Re: Initial Submission Review – Eagle Ridge Signage Site Plan with Adjustment
Application Number: **DA-2338-02**
Case Numbers: 2023-6061-00

First Submission Review

2E. An example of a data block is below:

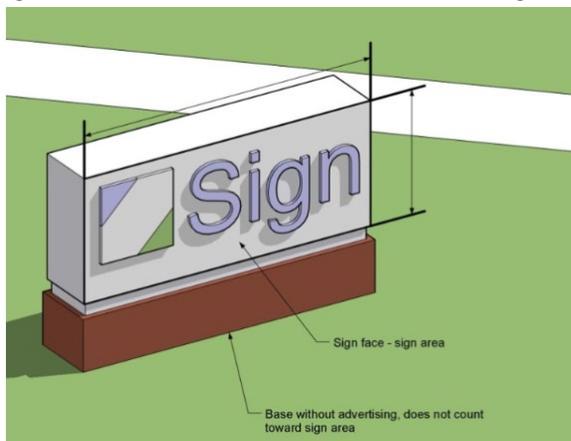
2D. Per the site plan manual, please provide an amendment block, signature block, required site plan notes, data block, and contacts.
